SUBJECT: SAFETY EVALUATION OF GE TOPICAL REPORT, NEDC-31858P, REVISION
2; "BWROG REPORT FOR INCREASING MSIV LEAKAGE LIMITS AND
ELIMINATION OF LEAKAGE CONTROL SYSTEMS," SEPTEMBER 1993

SAFETY EVALUATION BY THE OFFICE OF NUCLEAR REACTOR REGULATION
BWROG GENERIC RESOLUTION
FOR THE BWR MAIN STEAM ISOLATION VALVE LEAKAGE

FIG. 1

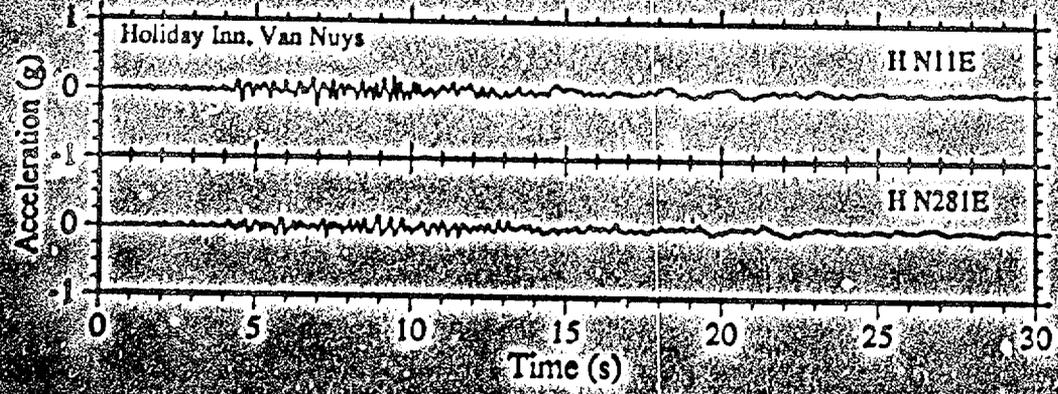
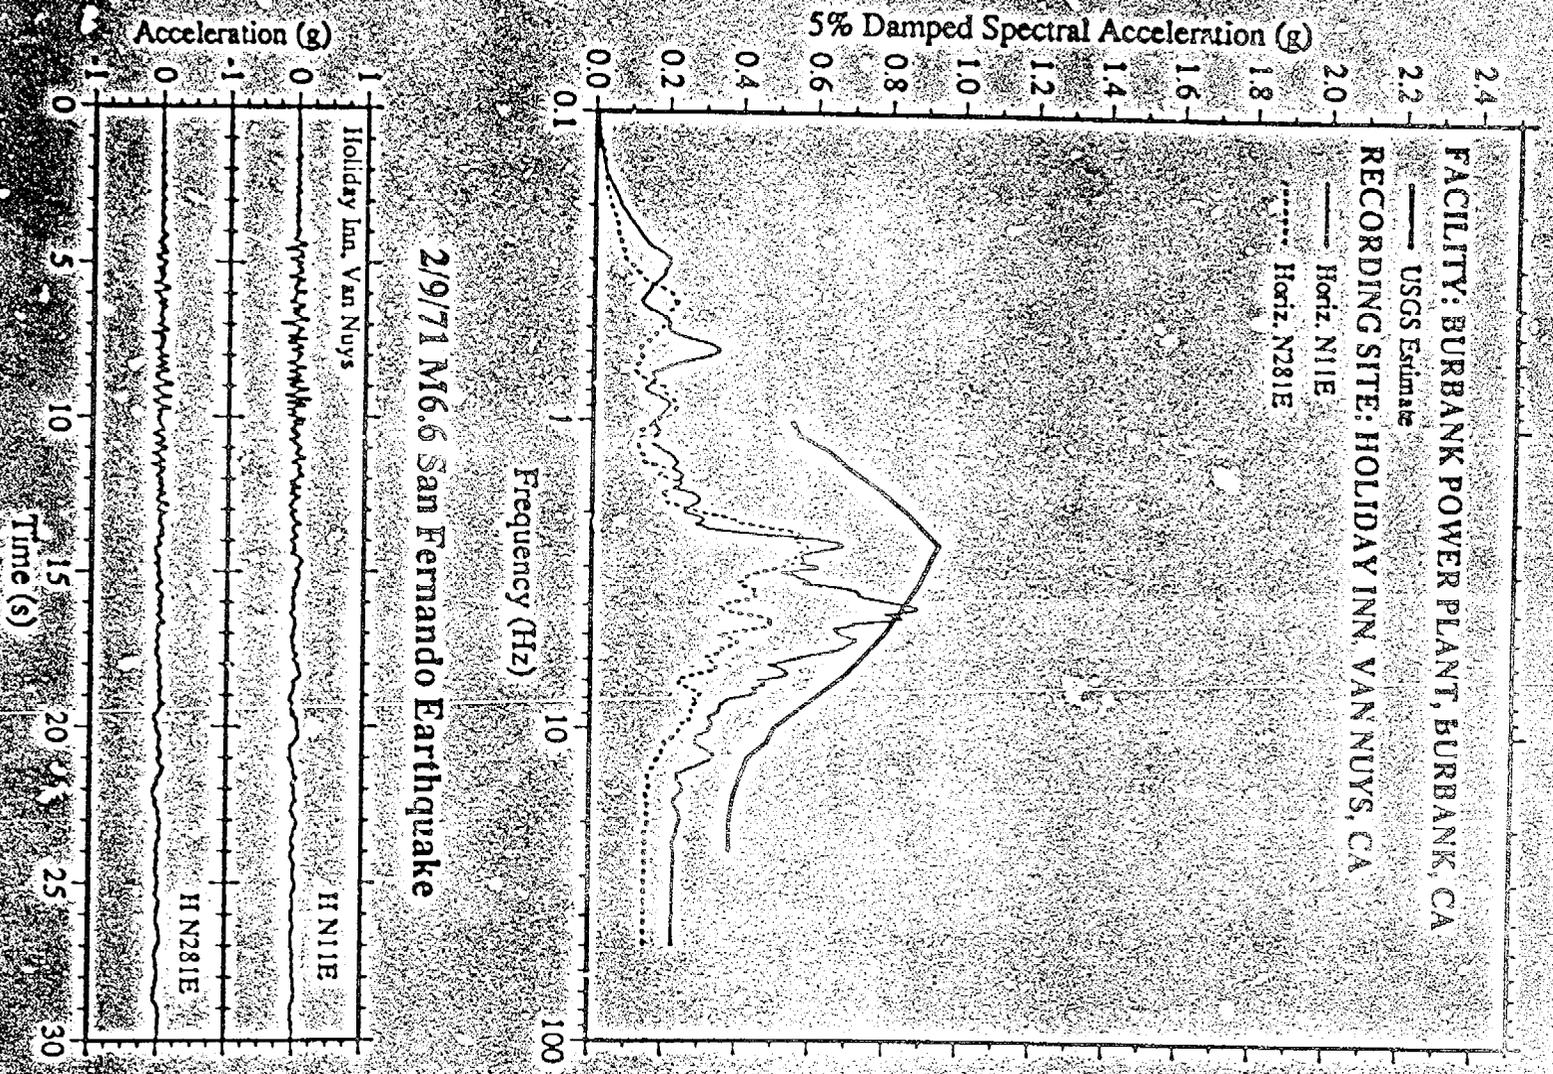
1971 San Fernando earthquake made at the Holiday Inn in Van Nuys, CA. The main adjustment made to the Holiday Inn record was to account for differences in ground motion attenuation between the recording site and the Valley Steam and Burbank facilities. USGS estimates for the Valley Steam and Burbank facilities as well as the Holiday Inn response spectrum and ground motion are shown in Figures 1 and 2, respectively.

The facility ground motion estimates shown in Figures 1 through 13 of this attachment have been reviewed and accepted by the staff for inclusion in BWROG's earthquake experience database. These 13 facility ground motion estimates may be used to verify the seismic adequacy of equipment in the alternative MSIV leakage pathway for plants referencing BWROG's Topical Report, NEDC-31858P, Revision 2. With the exception of the facility estimates for the Valley Steam Plant, the Burbank Power Plant, and the Moss Landing Power Plant, the nearby recording site or on-site response spectra, shown in the attached figures, should be used to estimate the facility ground motion. USGS estimated response spectra should be used for the Valley Steam Plant and the Burbank Power Plant and the PG&E estimated response spectrum should be used for the Moss Landing Power Plant.

FIG. 3

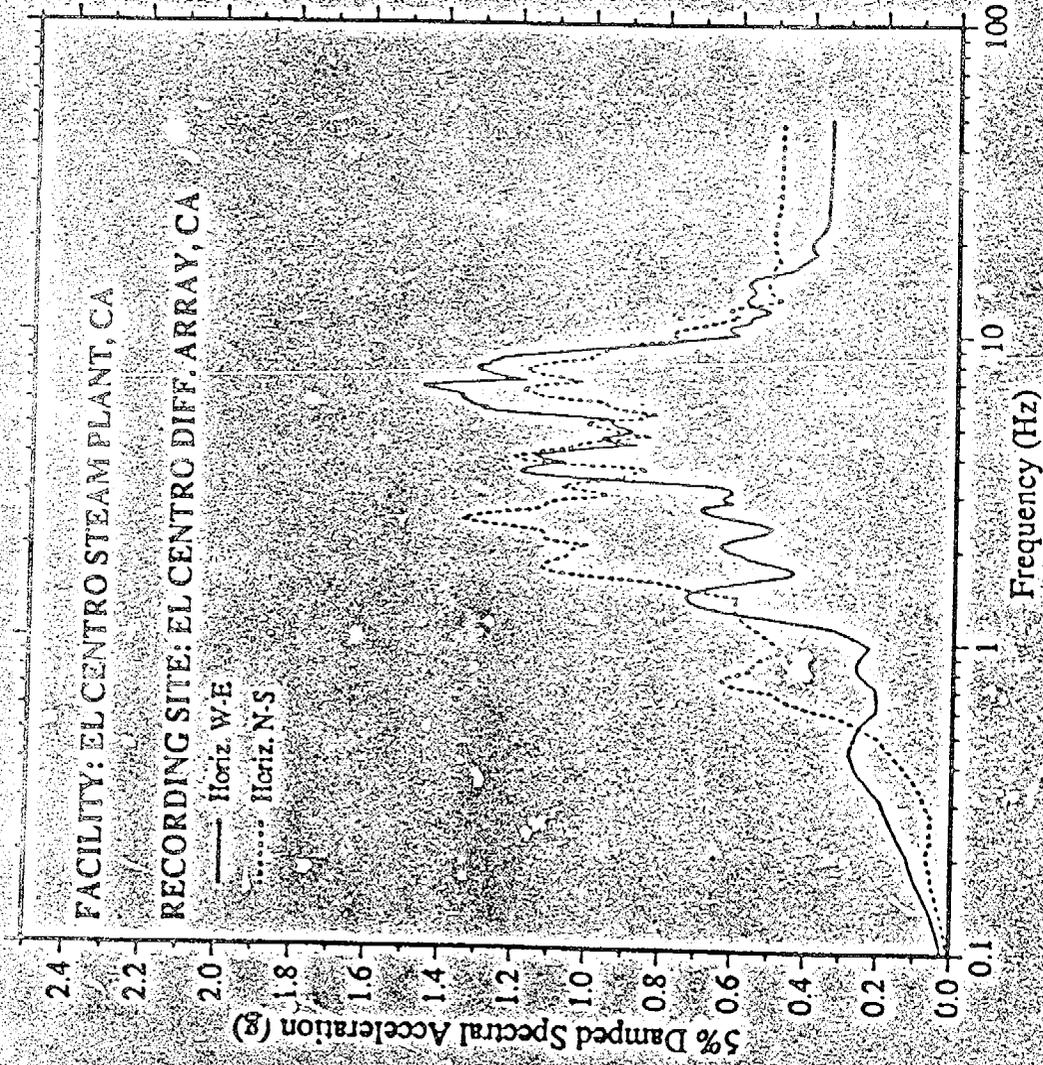
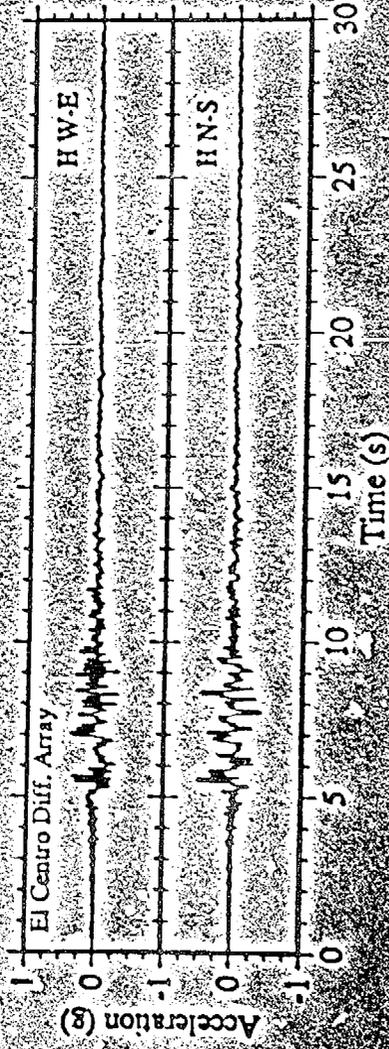
For the El Centro Steam Plant in El Centro, CA, the closest recording site is less than 2 km from the plant and is underlain by similar soils. In addition, there were several other seismic instruments in the area that also recorded the 1979 M6.6 Imperial Valley earthquake. Variations in the ground motion from this earthquake were extensively studied and reported in the literature. Therefore, the staff was able to conclude that the seismic recording site and the El Centro Steam Plant experienced similar levels of ground motion. The recording site ground motion and response spectra are shown in Figure 3.

FIG. 4

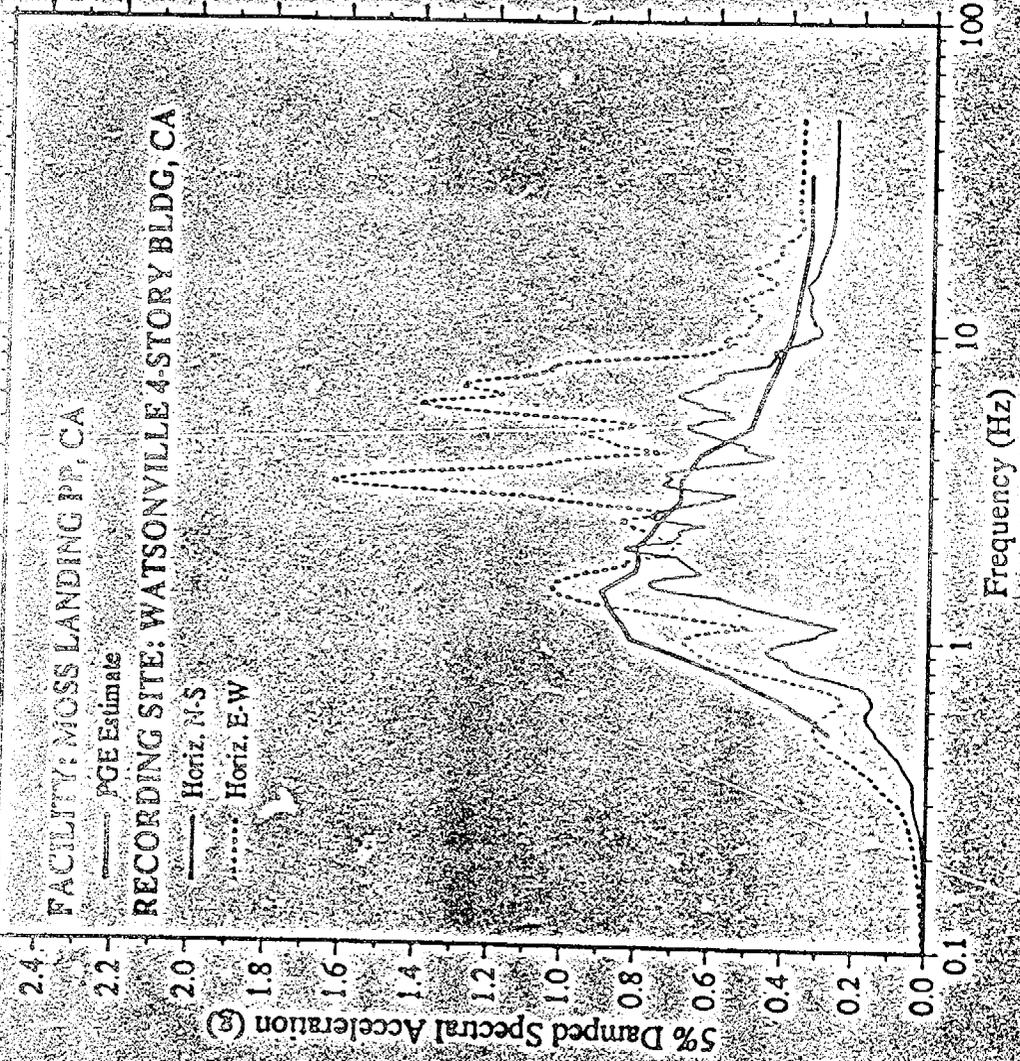
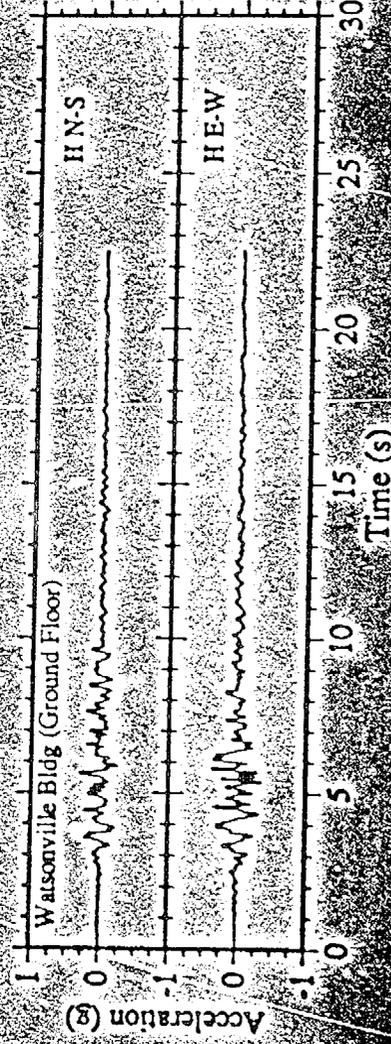
The EQE estimate of ground motion at the Moss Landing Power Plant is based on a study performed by Pacific Gas and Electric (PG&E), the owner of the Moss Landing Power Plant. The staff concluded that this estimate of ground motion at the Moss Landing facility from the 1989 M7.1 Loma Prieta earthquake is technically sound and comprehensive. The PG&E estimate, as well as the ground motion and response spectra from the nearest recording site in Watsonville, CA, are shown in Figure 4.

FIG. 5

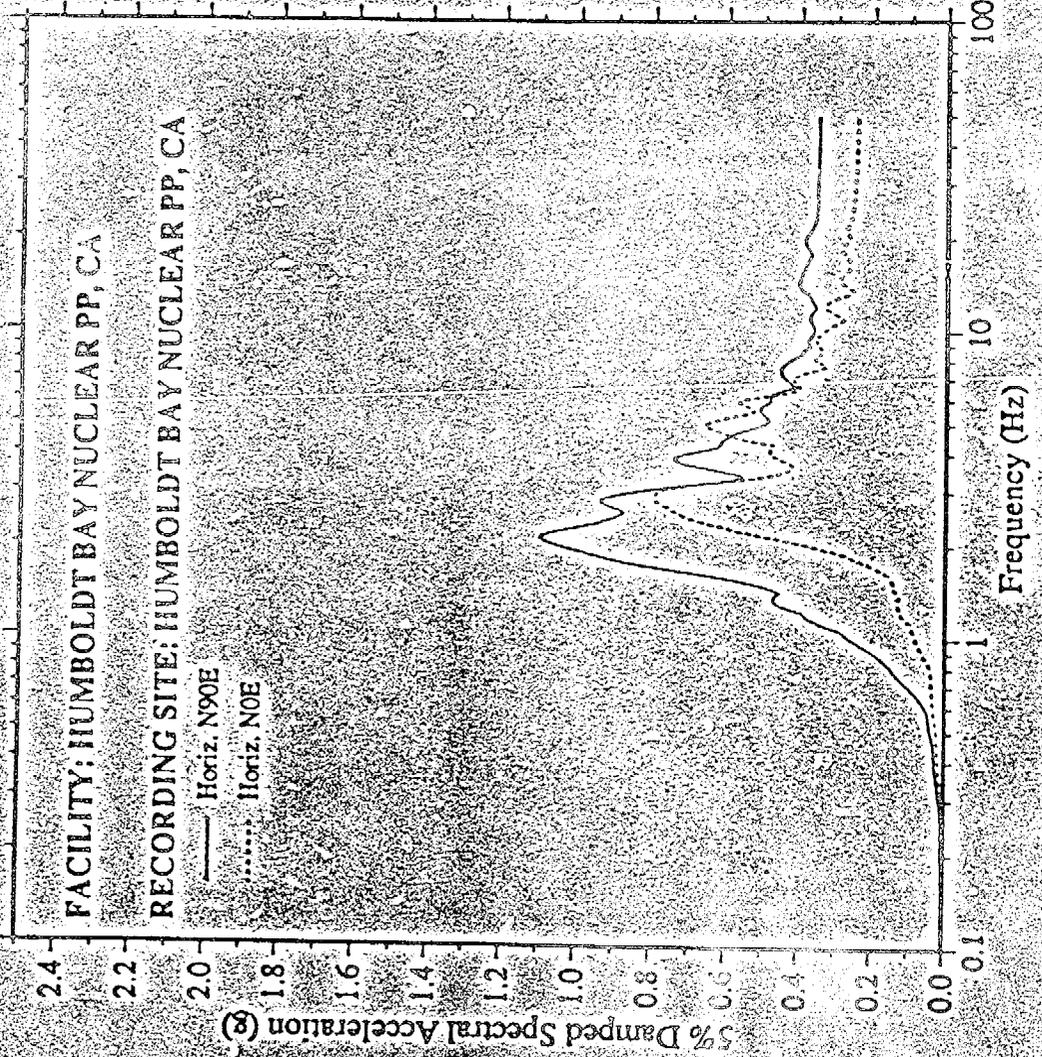
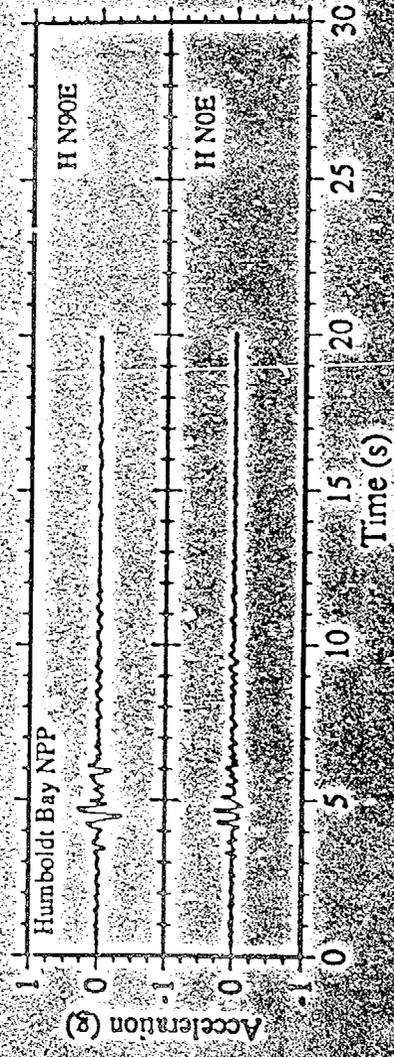
On-site recordings of ground motion made at Humboldt Bay Power Plant (HBPP) from the 1975 M5.5 Ferndale earthquake and the 1992 M6.9 Petrolia mainshock and M6.2 aftershock are shown in Figures 5, 6, and 7, respectively. EQE also listed an additional 1992 Petrolia aftershock in the earthquake experience database. However, the response spectrum at HBPP from this aftershock is enveloped by the three other HBPP response spectra. For the 1980 M7.2 Eureka earthquake, listed in the database, only a scratch plate record of the response spectrum at 2% of critical damping was made at HBPP. Since the accuracy of this record is questionable, the staff does not accept this facility-event pair for inclusion in the database.

FIG. 8

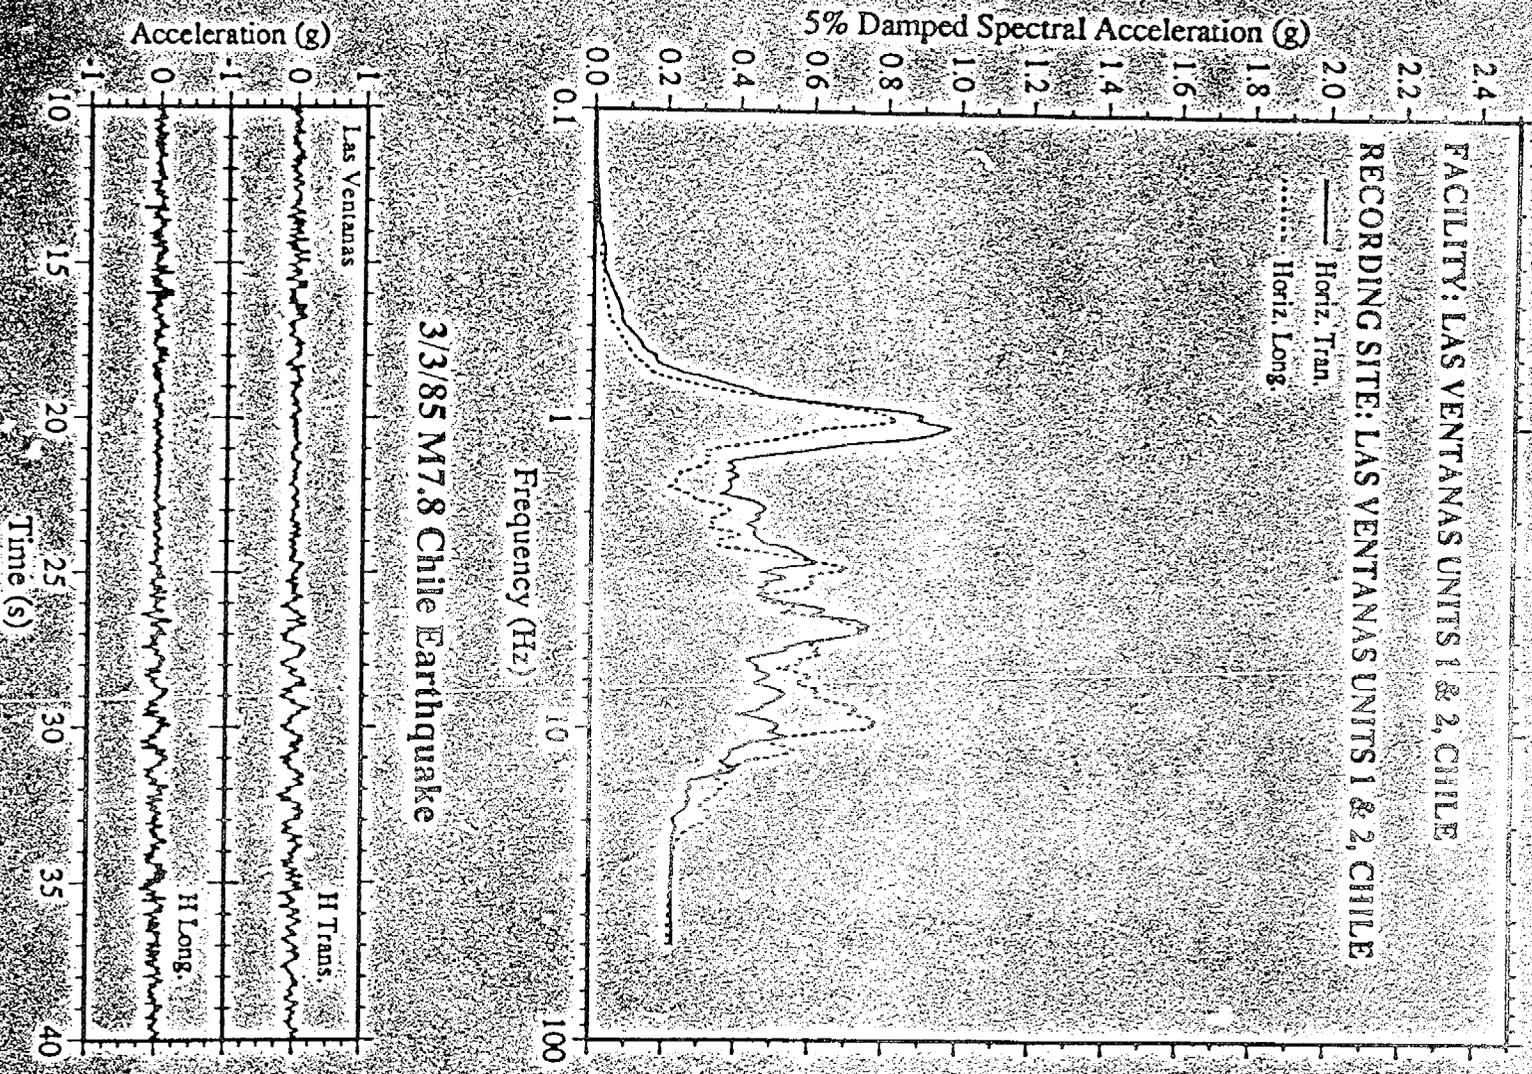
On-site recordings made at Las Ventanas Units 1 & 2 in Quintero Bay, Chile, from the 1985 M7.8 Valparaiso earthquake, shown in Figure 8, have been reviewed and accepted by the staff. Also, the staff has reviewed and accepted the on-site recording made at Coolwater Power Plant in Dagget, CA, of the 1992 M7.3 Landers earthquake, shown in Figure 9. The staff has not reviewed the Coolwater recording of the 1992 M6.5 Big Bear earthquake. However, the ground motion response spectrum from this event is most likely enveloped by the Coolwater spectrum of the Landers earthquake.

FIG. 10

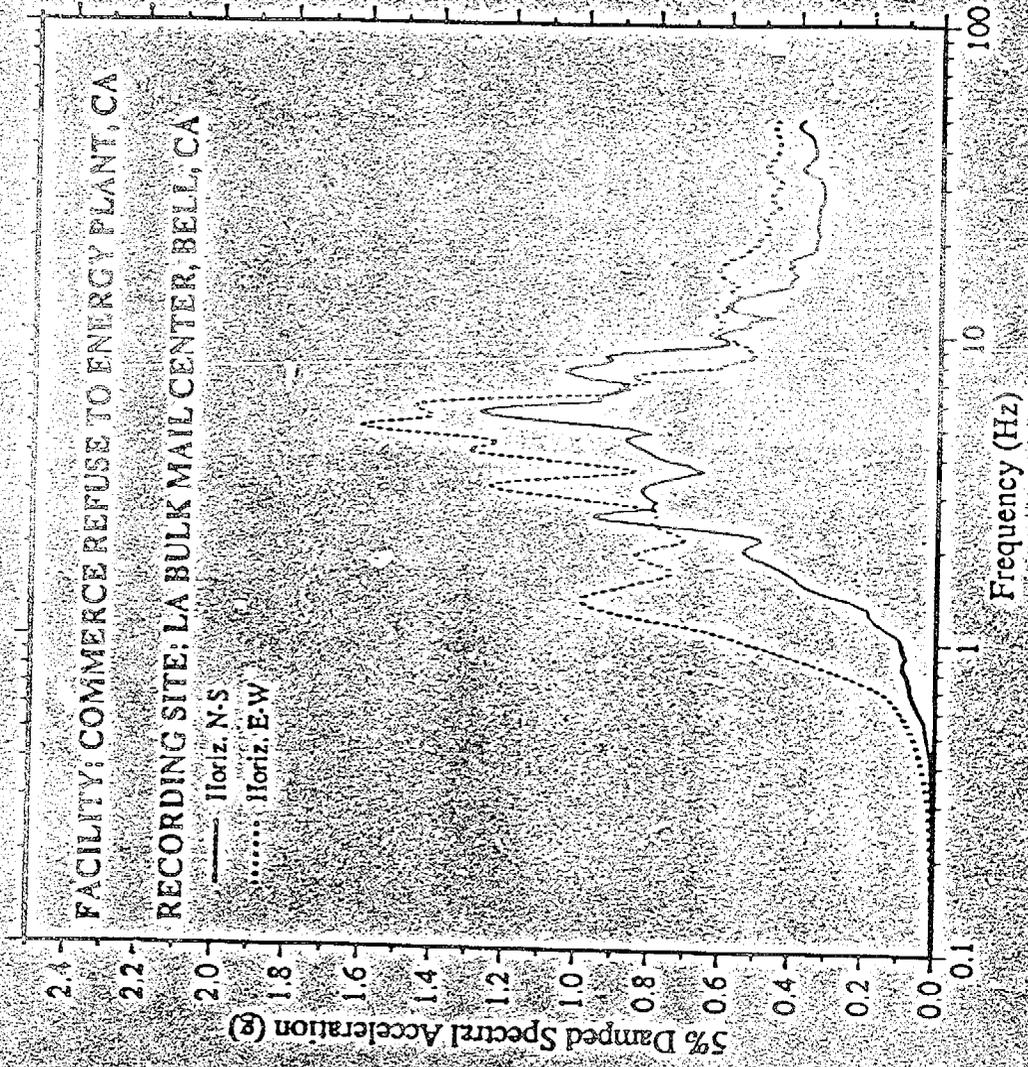
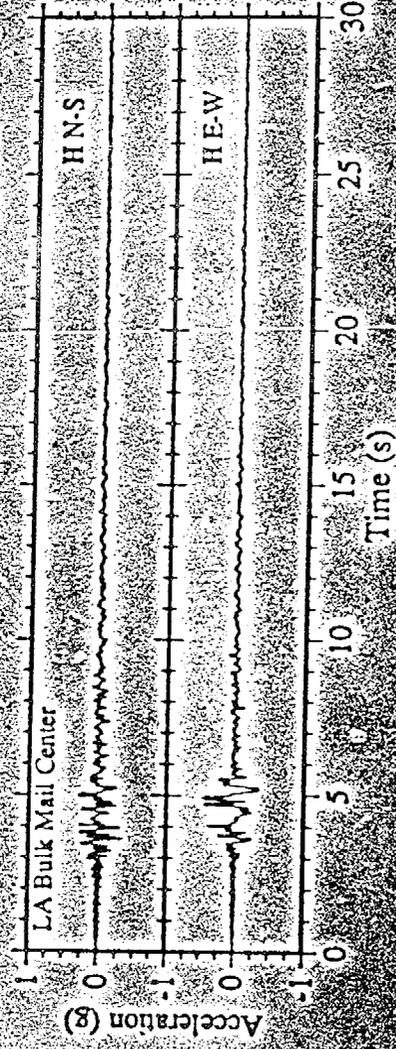
The Commerce Refuse to Energy Plant is located about 1 km from a site that recorded the 1987 M5.9 Whittier Narrows earthquake. Both the facility and recording sites are located on thick alluvium deposits. The seismic recording made at the Bulk Mail Facility in Bell, CA, is an acceptable estimate of the ground motion at the Commerce Refuse to Energy Plant. Figure 10 shows the response spectra and ground motion for the two horizontal components at the recording site in Bell, CA.
